**BRIDGEPORT WEST SEWER IMPROVEMENTS
SECTION C – LIFT STATION IMPROVEMENTS
CITY OF SIOUX CITY, IOWA
Project No. 6827C-539-201 – 2016**

ADDENDUM NO. 2

March 3, 2016

SHEET NO.
E.01

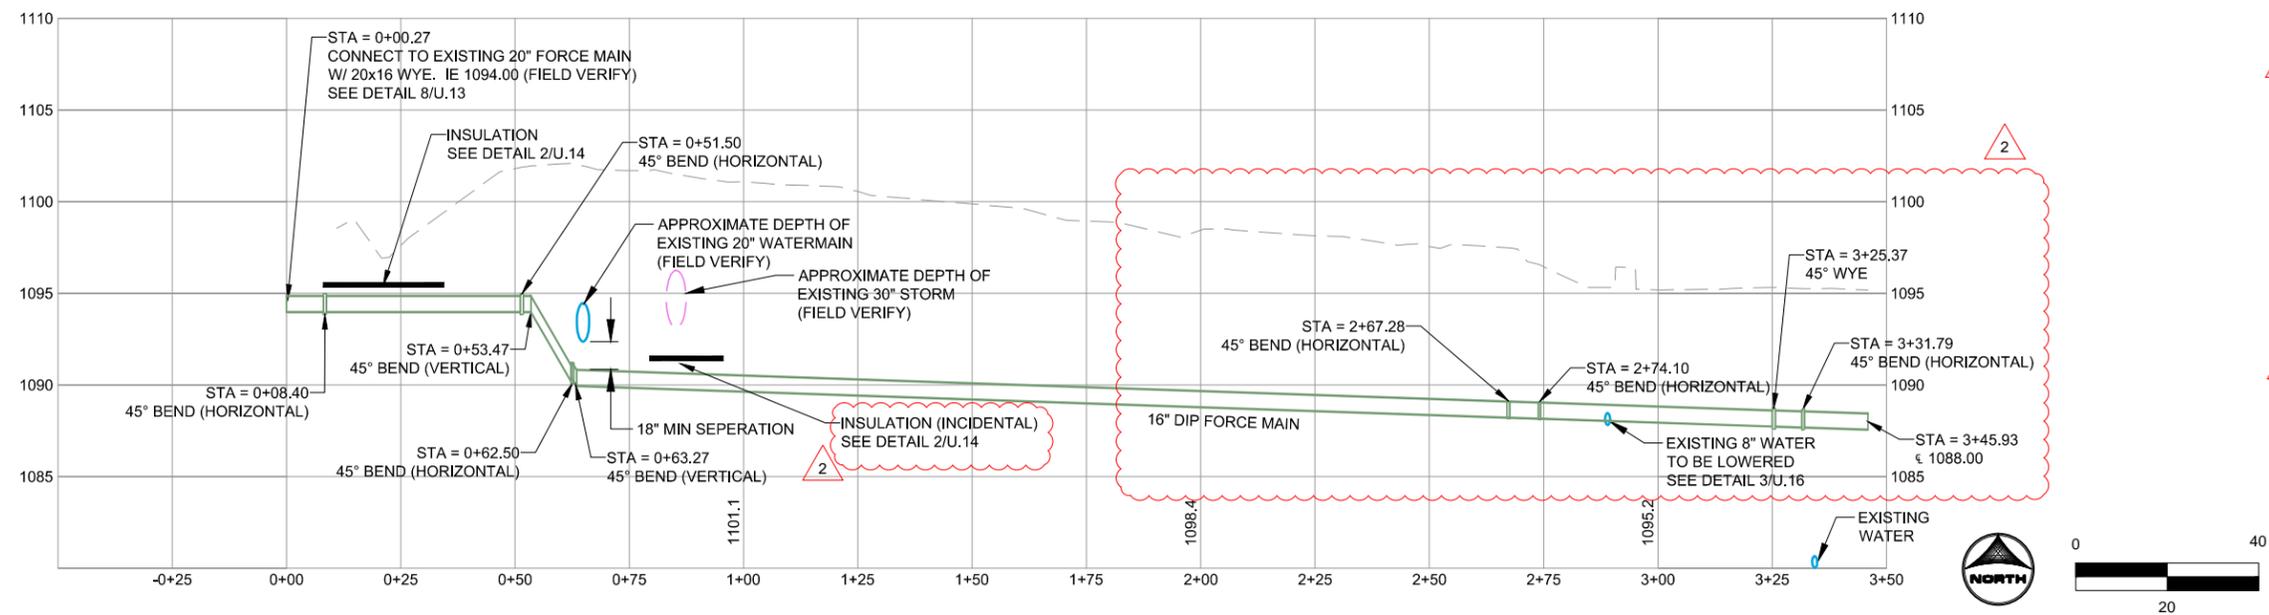
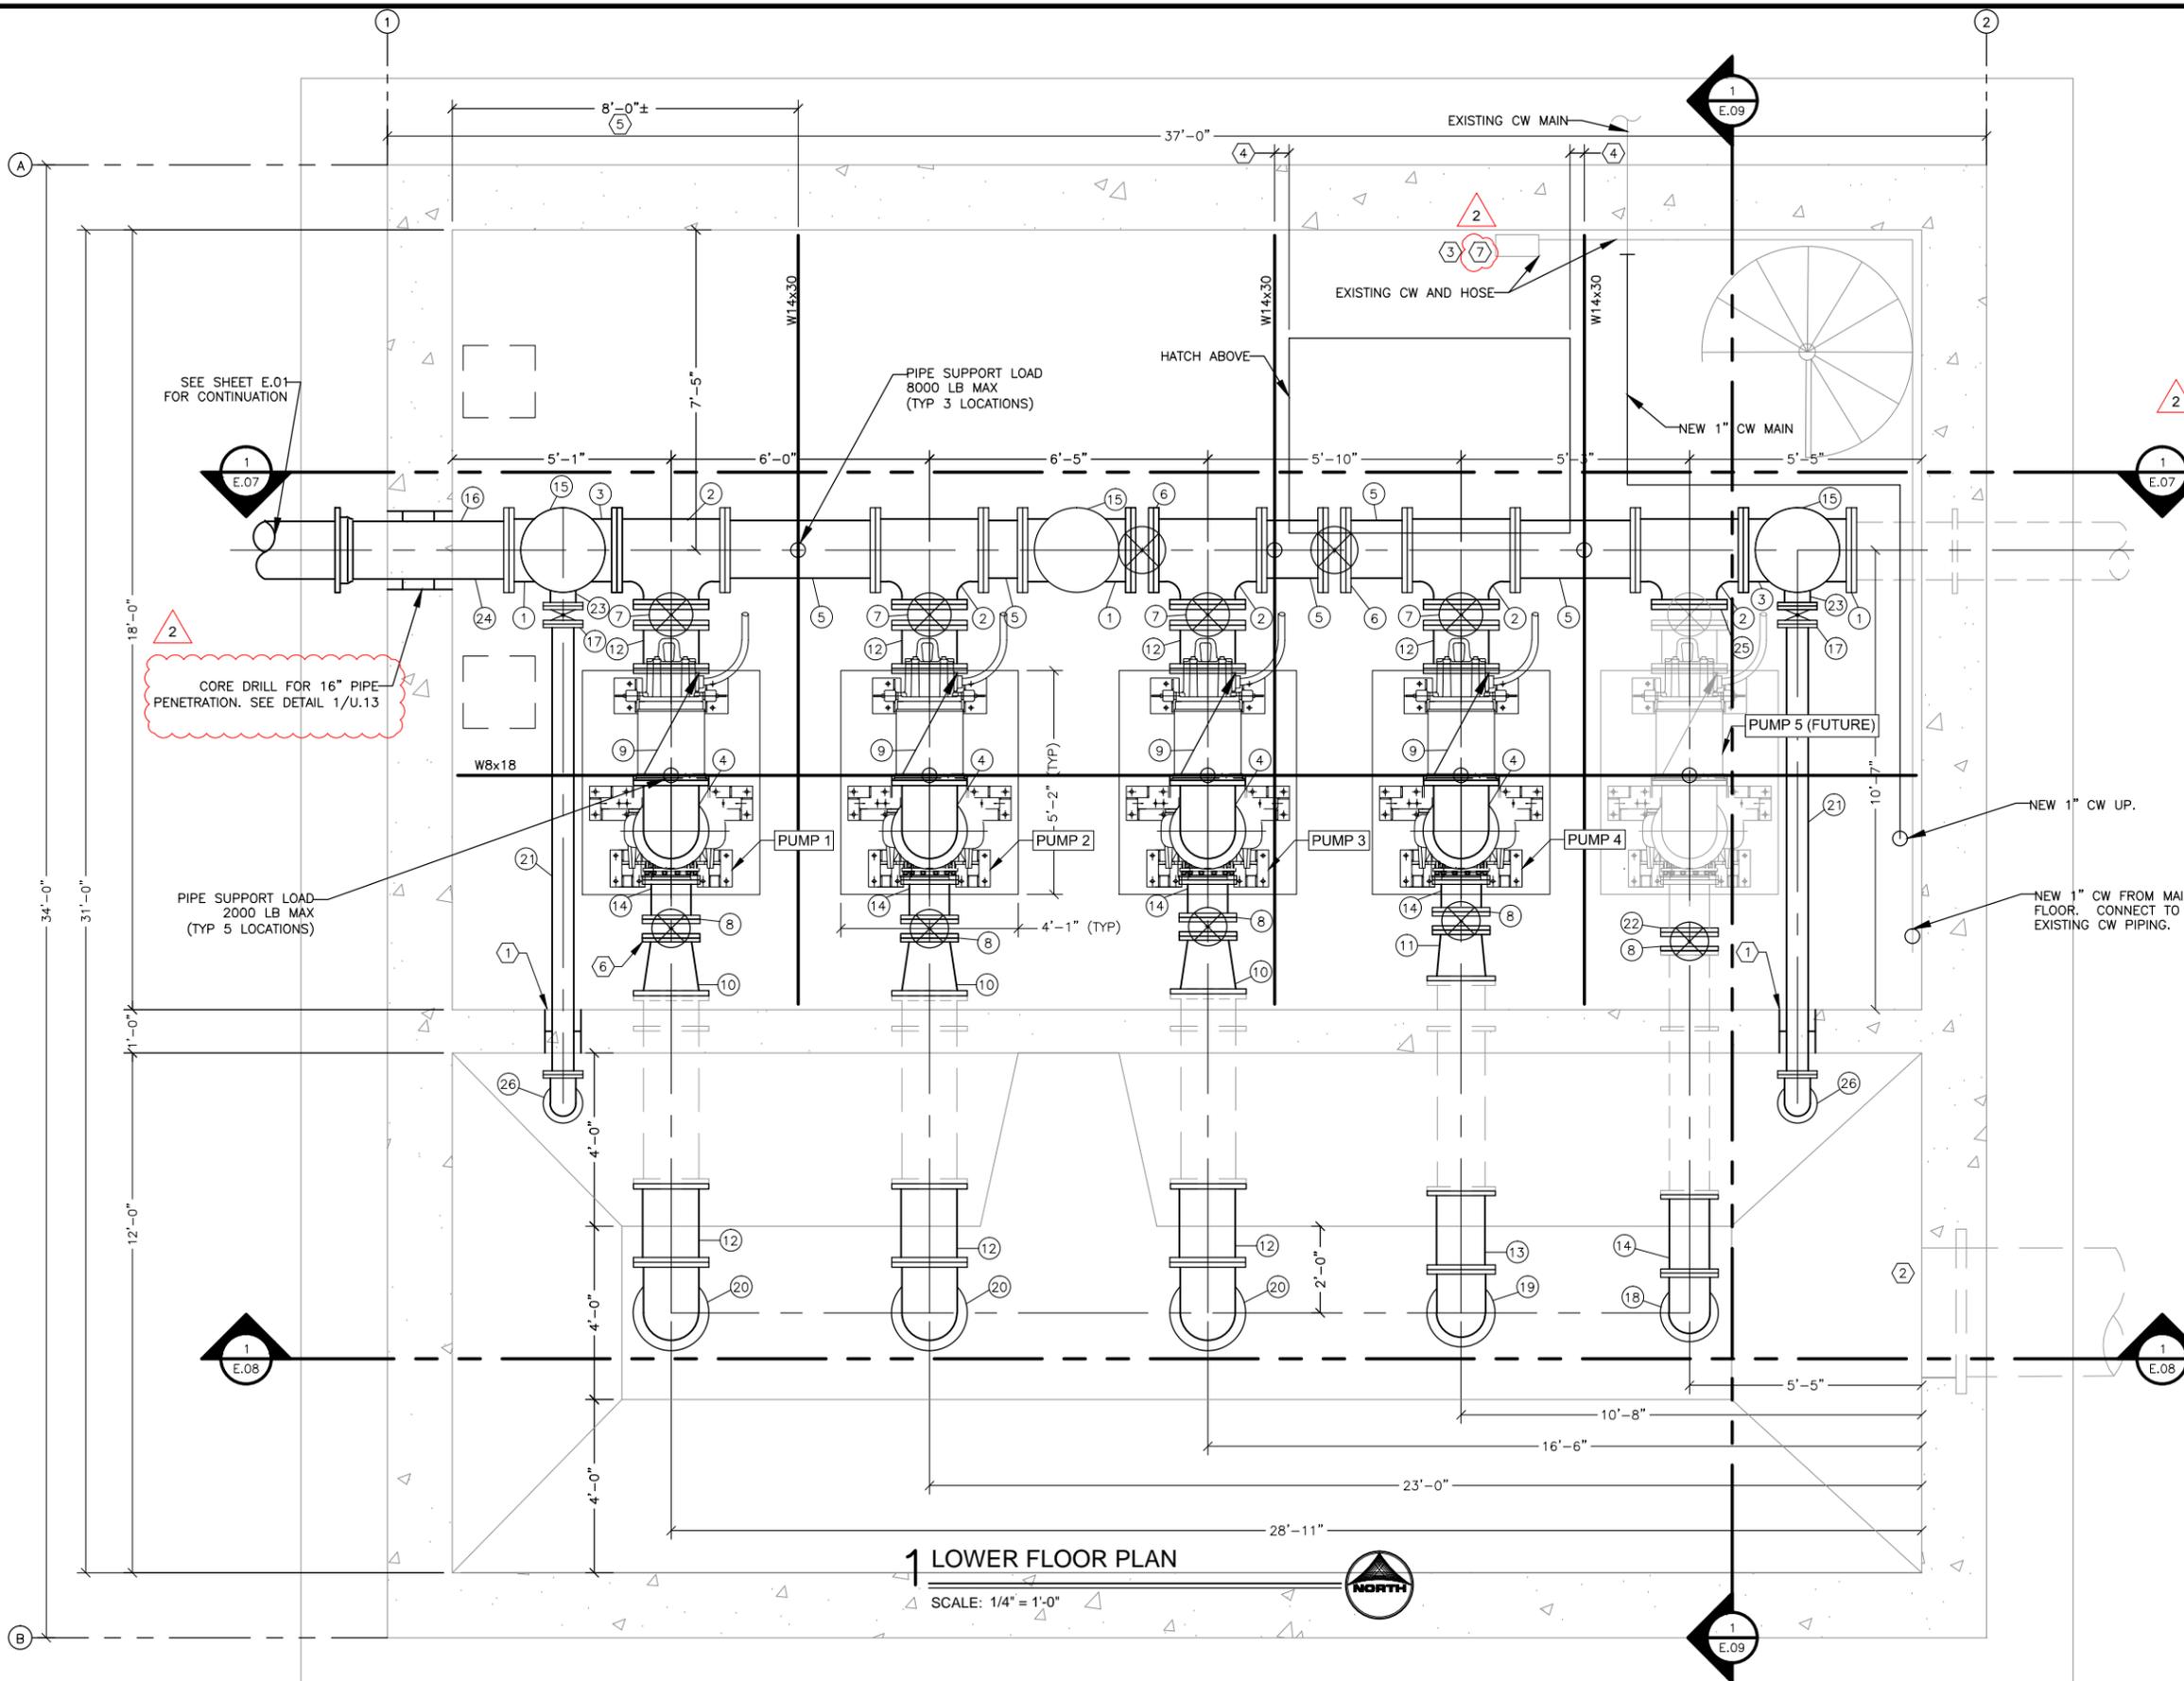
NO.	DATE	BY	REVISION DESCRIPTION
2	3/2/16	JV	REVISE FORCEMAIN PROFILE, REMOVE BYPASS ROUTE

ADDENDUM #2
 SHEET NO.
E.05

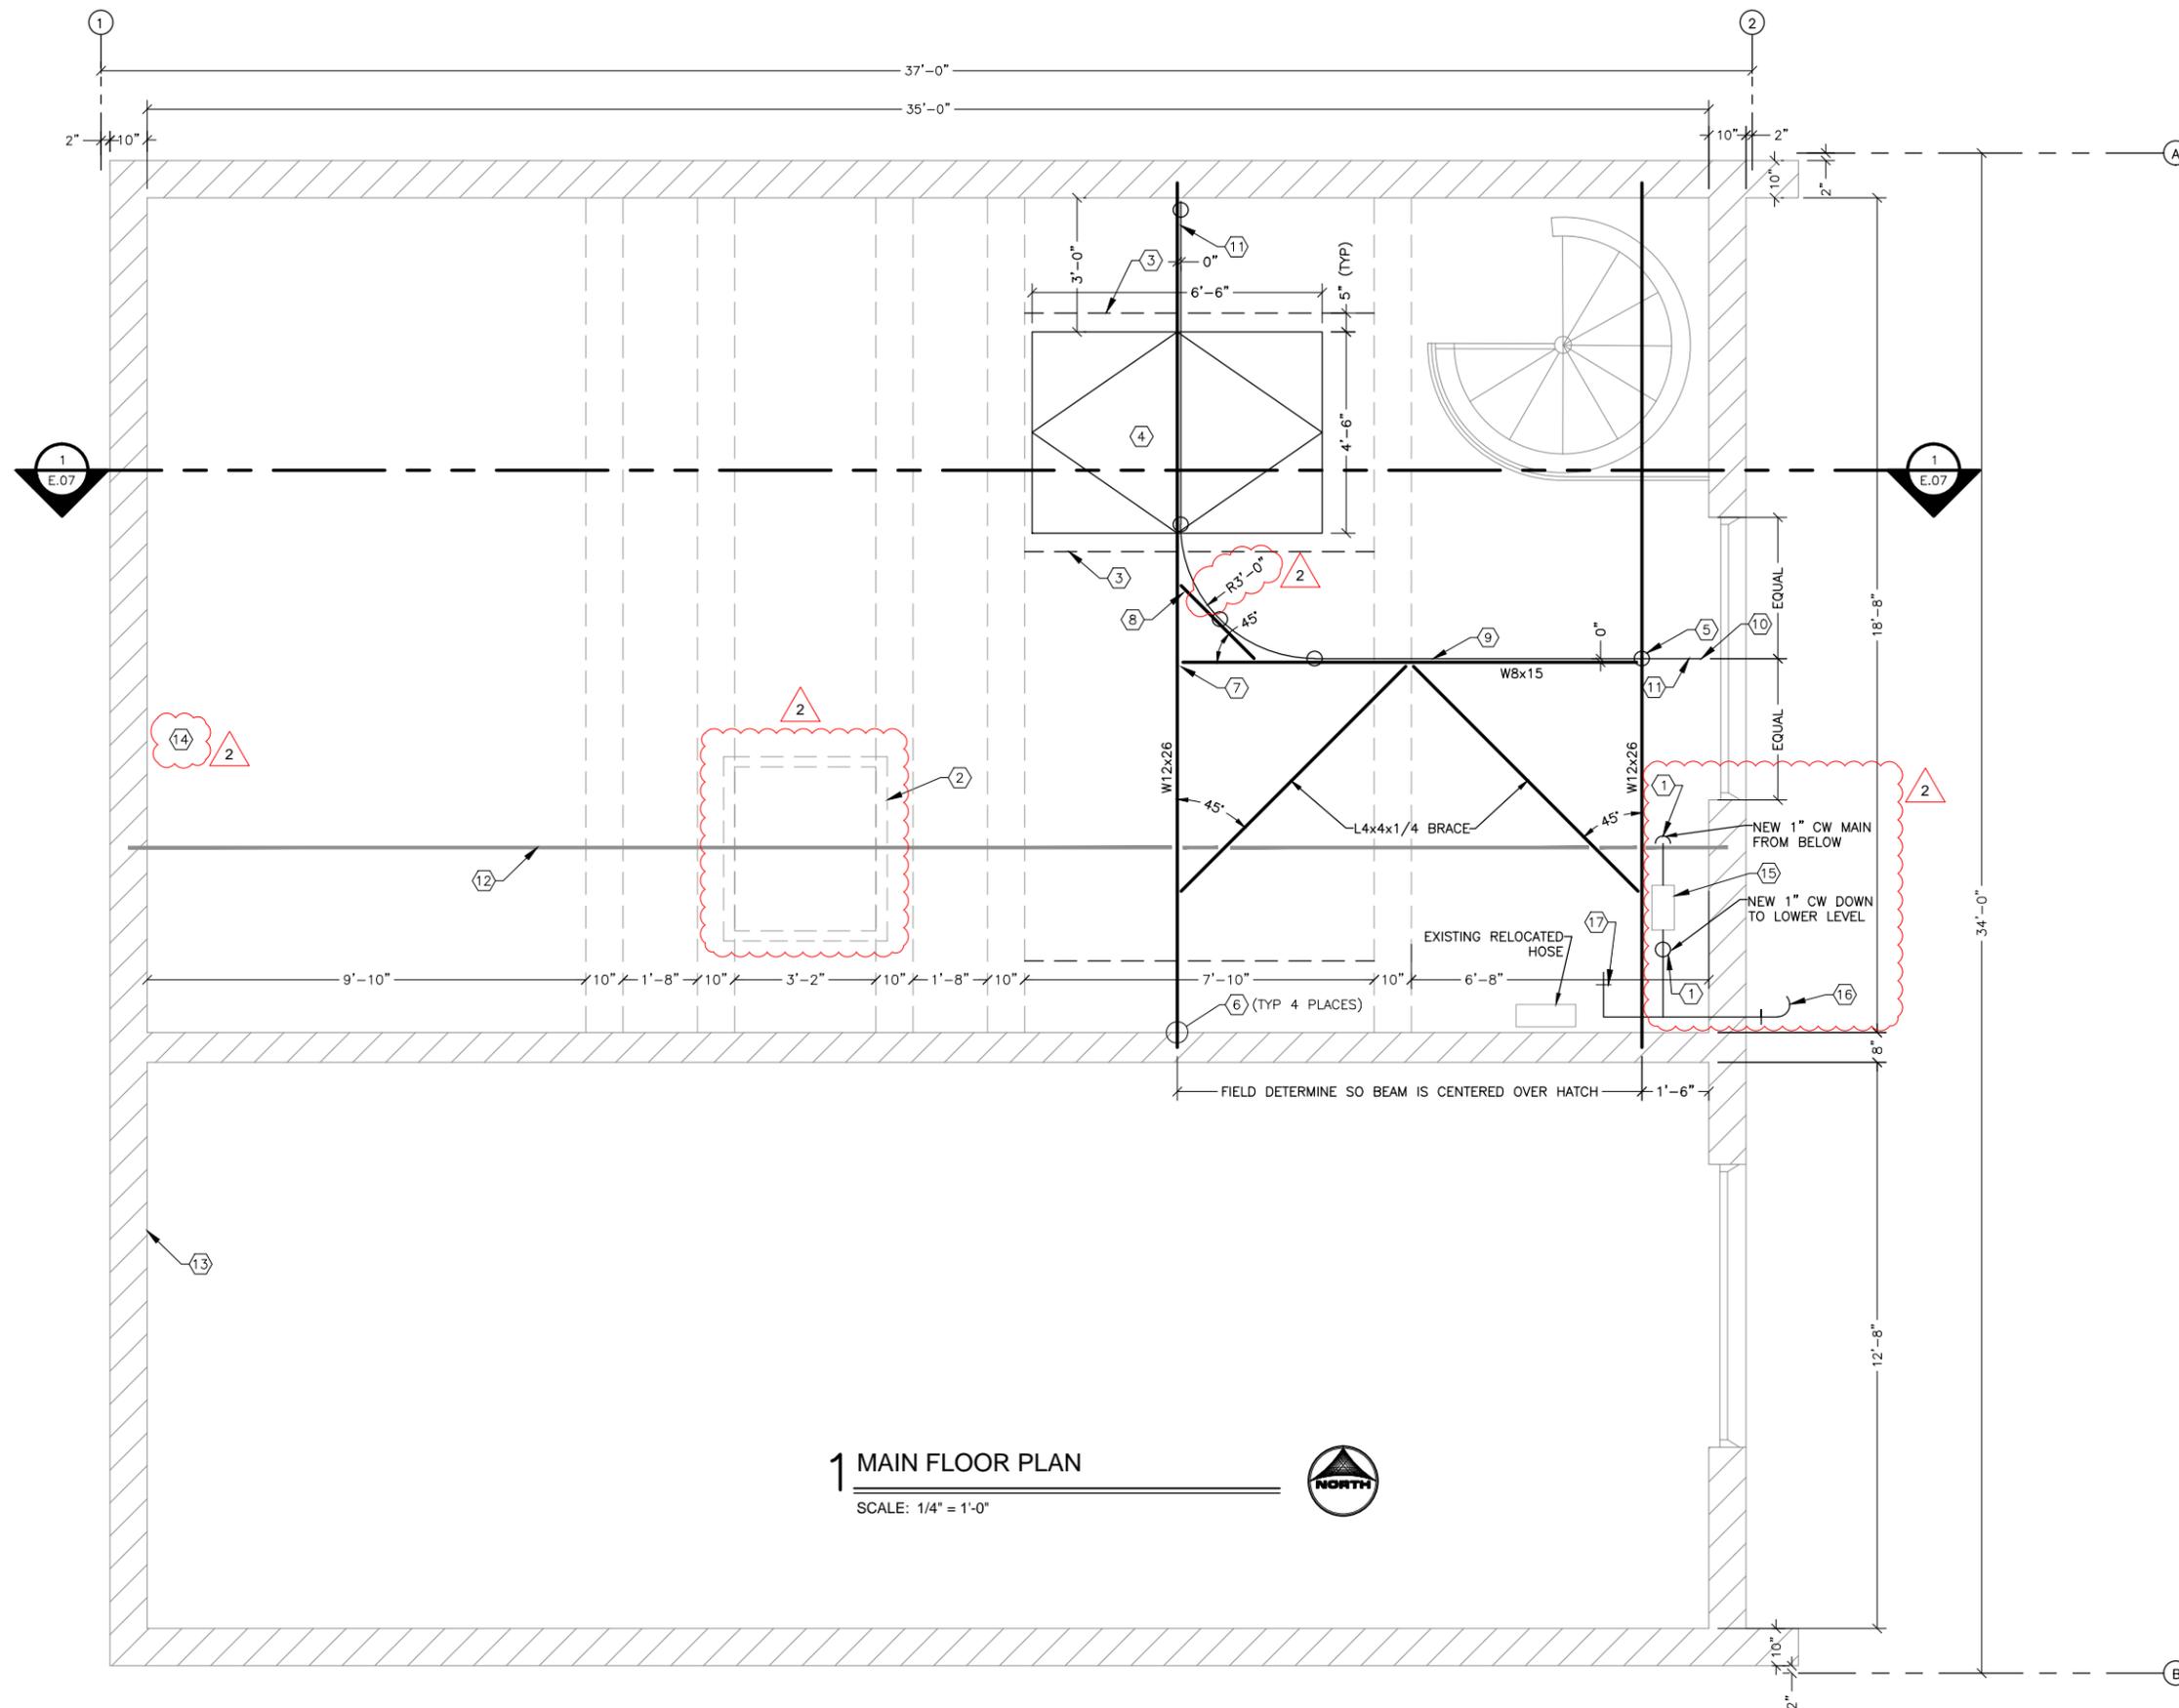
NO.	DATE	BY	REVISION DESCRIPTION
2	3/2/16	JV	ADD KEY NOTE 7, EDIT CORE DRILL NOTE

- KEY NOTES:**
- ① CORE DRILL FOR 6" SURGE VALVE RELIEF PIPING. SEE 1/U.13.
 - ② ALL SURFACES OF WET WELL TO BE CLEANED AND LINED. SEE SPEC 09 9600.01 FOR CORROSION PROTECTIVE LINING REQUIREMENTS.
 - ③ DRY WELL SURFACES AND STAIRS TO BE BLASTED, CLEANED, AND PAINTED. SEE SPEC 09 9000 - PAINTING AND COATING FOR REQUIREMENTS.
 - ④ MINIMIZE DIMENSION 4"±. DO NOT ALLOW BEAM FLANGE TO PROTRUDE INTO HATCH CLEAR OPENING.
 - ⑤ CENTER BETWEEN PUMP 1 AND 2.
 - ⑥ USE NEW 10" KNIFE GATE VALVE CURRENTLY BEING STORED IN LOWER LEVEL DRY WELL.
 - ⑦ REMOVE CW LINE AND HOSE PRIOR TO BLASTING AND REPLACE UPON COMPLETION OF BLASTING.
